UPDATE REPORT

BY THE DIRECTOR FOR ECONOMIC GROWTH AND NEIGHBOURHOOD SERVICES
READING BOROUGH COUNCIL
PLANNING APPLICATIONS COMMITTEE: 5 February 2020

App No: 191634

Address: Hamilton Centre, 135 Bulmershe Road, Reading, RG1 5SG

Figure 4 - Proposed site plan (annotated)

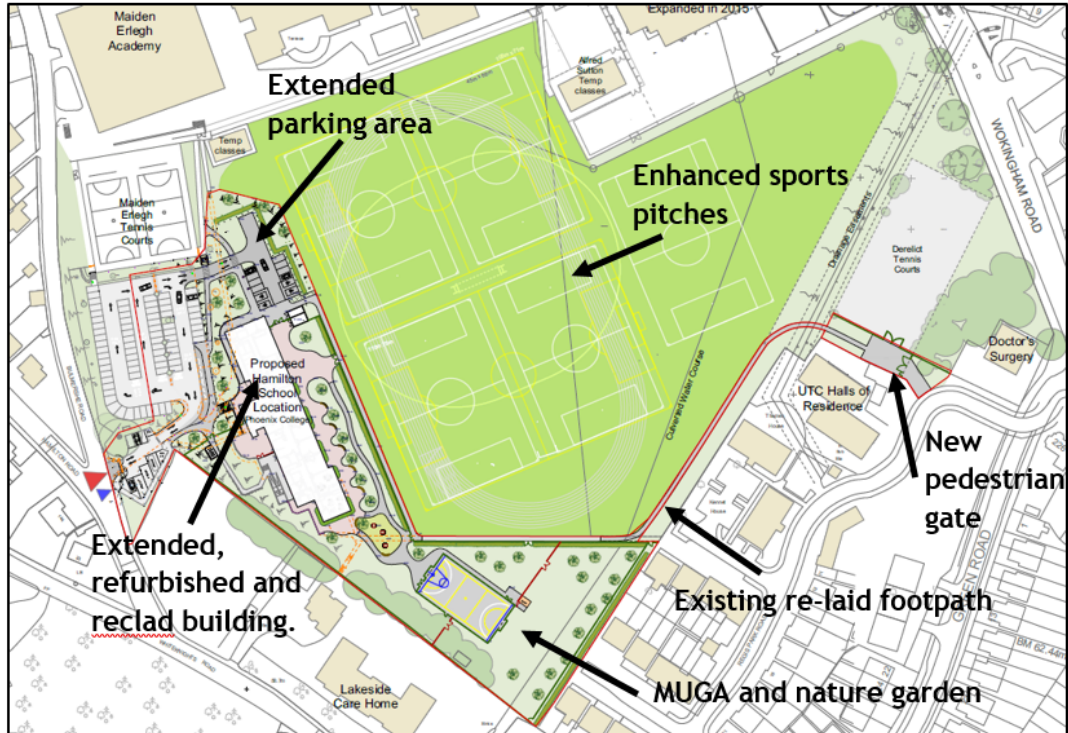
- 2.1 Members and interested parties should be aware that a formatting misalignment has occurred during publication of the PAC report. This had caused the illustration arrows within Figure 4 and 7 of this item within the main agenda to misalign showing incorrect reference points. Corrected versions of these illustrations are included below:
